NOTICE OF TENTATIVE DECISION

DATE OF REPORT: March 28, 2018
FILE: CU-03-18
TYPE OF APPLICATION: Conditional Use Review to add a two-classroom, 28-foot by 64-foot modular building to the existing North Albany Elementary School.
REVIEW BODY: Planning Staff (Type II)
PROPERTY OWNER / APPLICANT: Russ Allen, Greater Albany School District, 718 Seventh Avenue SW, Albany, OR 97321
REPRESENTATIVE: Rich Catlin, Reece & Associates Inc.; 321 1st Avenue E., Suite 3A, Albany, OR 97321
ADDRESS/LOCATION: 815 East Thornton Lake Drive NW
MAP/TAX LOT: Linn County Assessor's Map No. 10S-04W-36DD Tax Lot 700 and 800
ZONING: RS-10 – Residential Single-Family District

NORTH ALBANY ELEMENTARY SCHOOL SITE PLAN

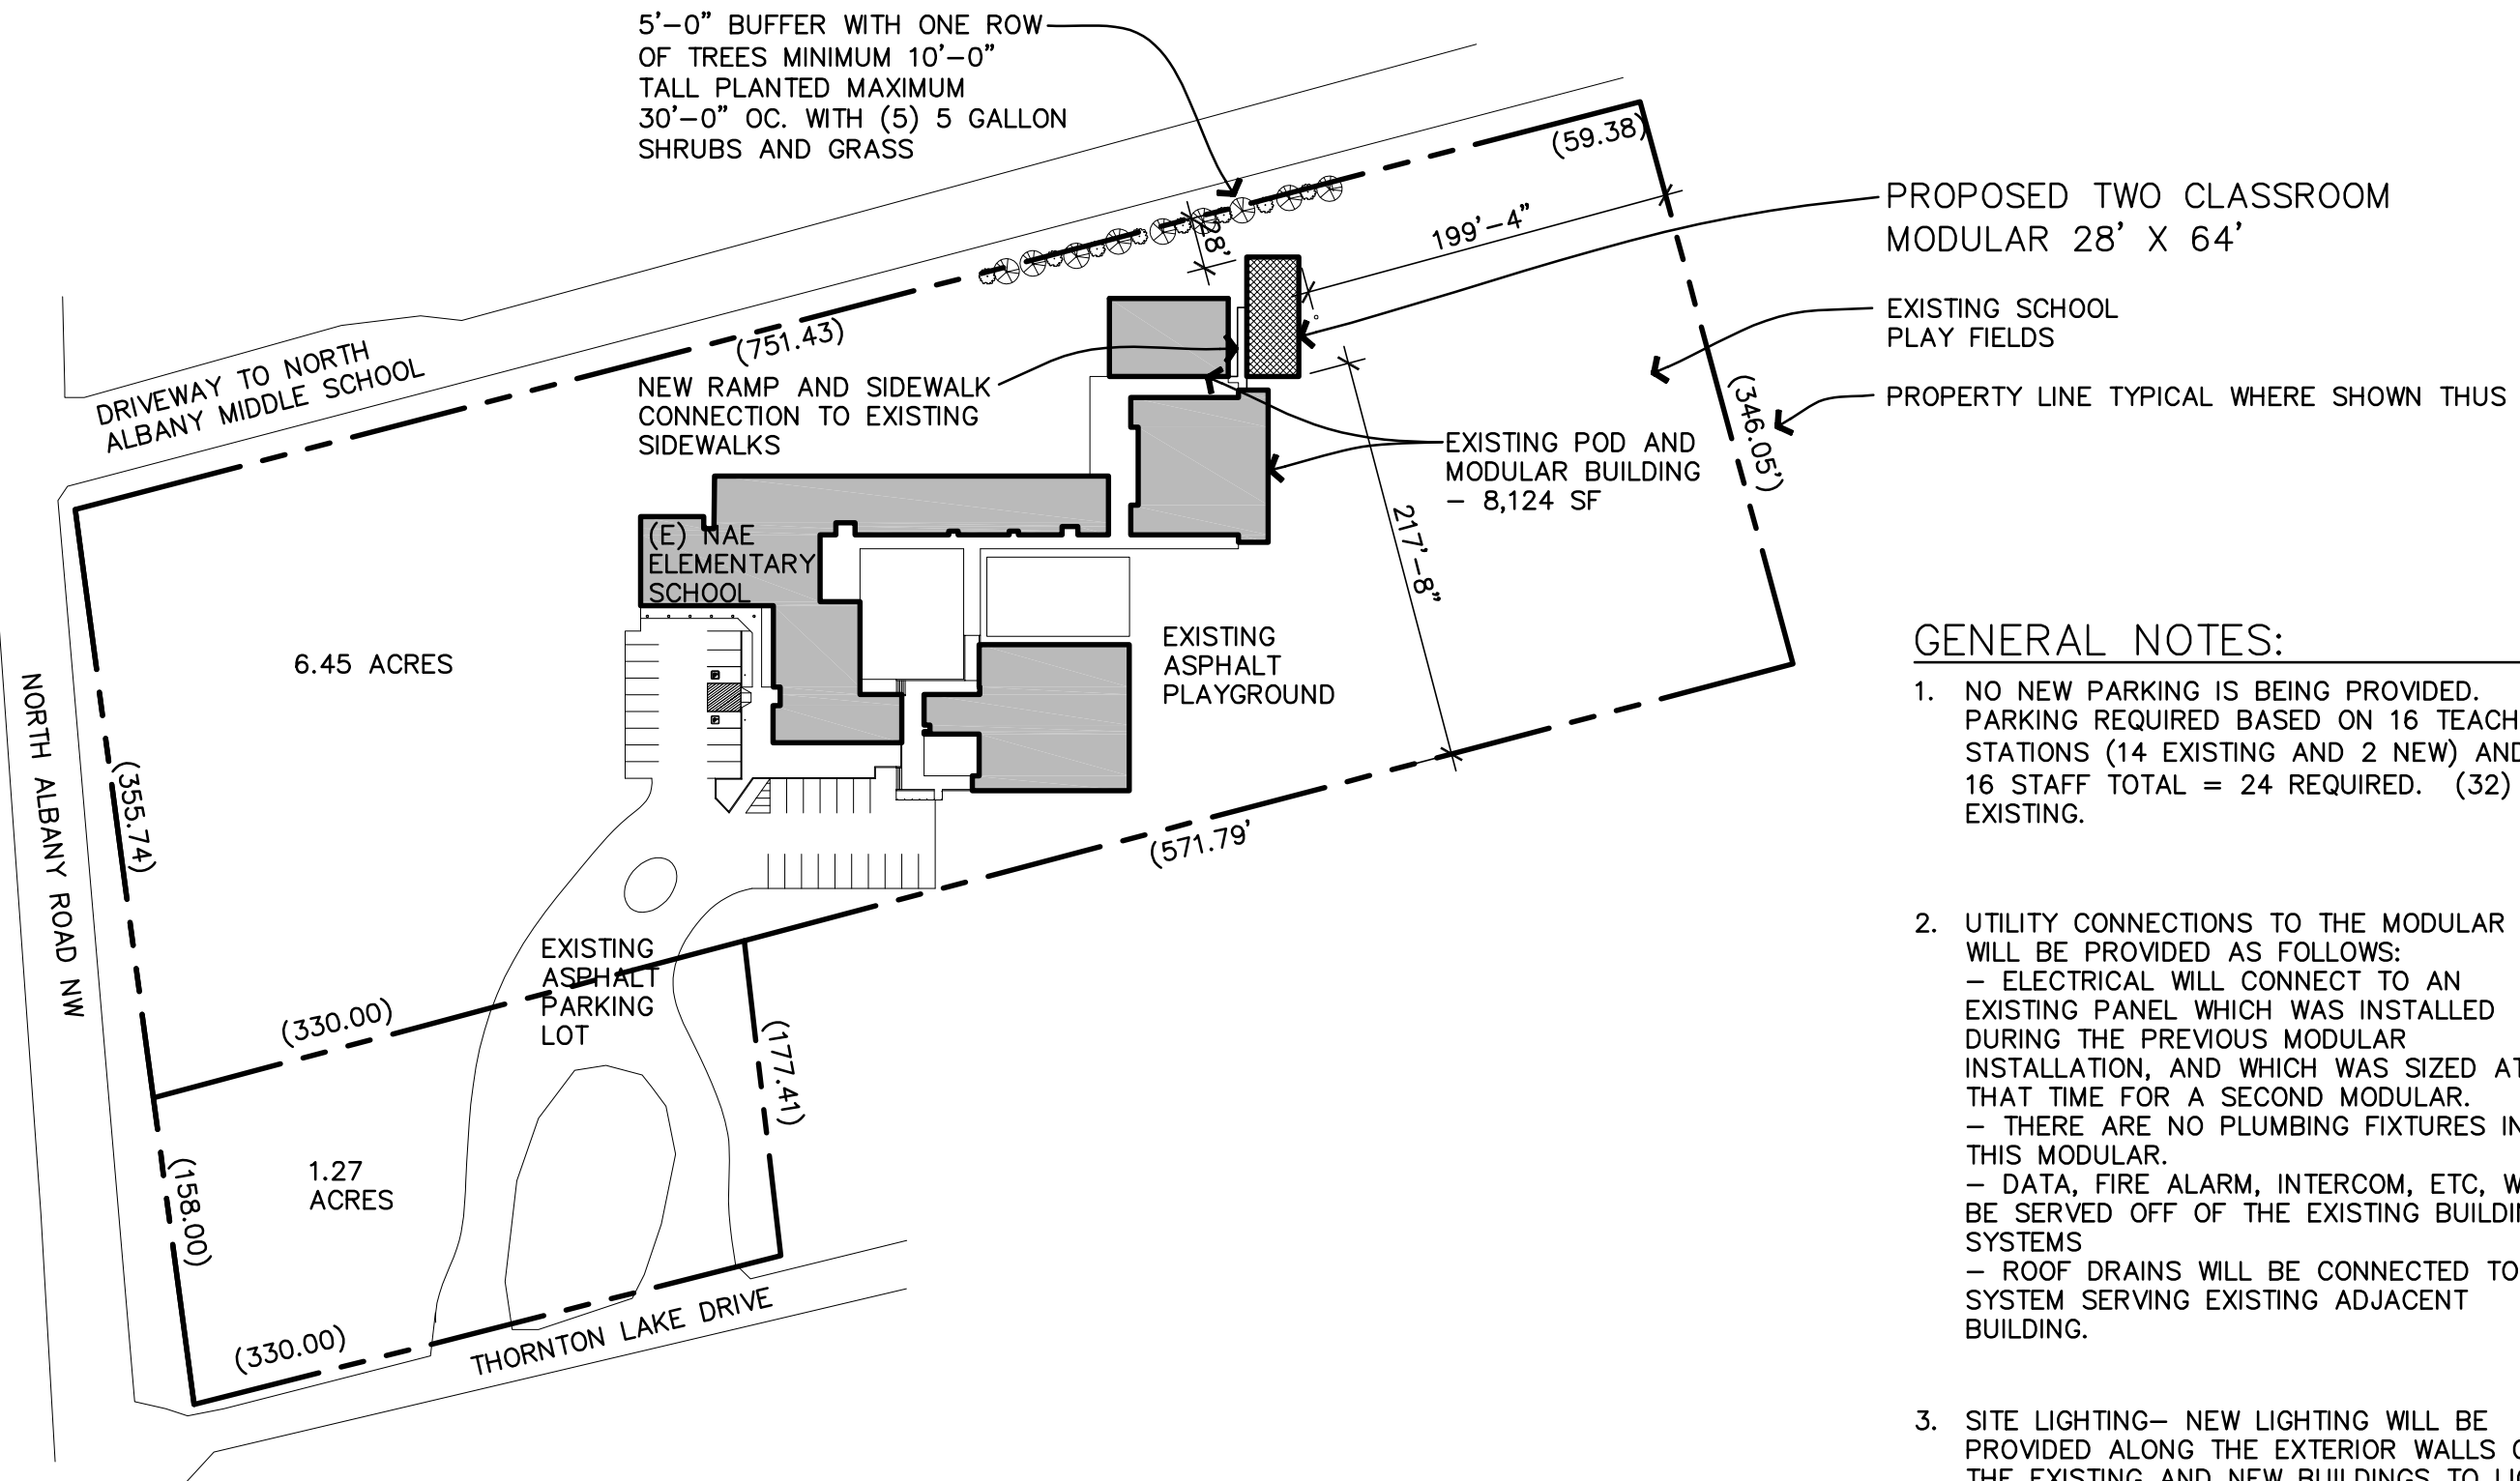
1. Landscape buffering shall be provided between the northern property boundary and the proposed modular building, in accordance with ADC 9.240. As proposed on the site plan, landscaping shall include a five-foot-wide, 200-foot-long buffer with one row of trees a minimum of 10 feet tall planted, spaced a maximum of 30 feet on center with five five-gallon shrubs. and grass ground cover.
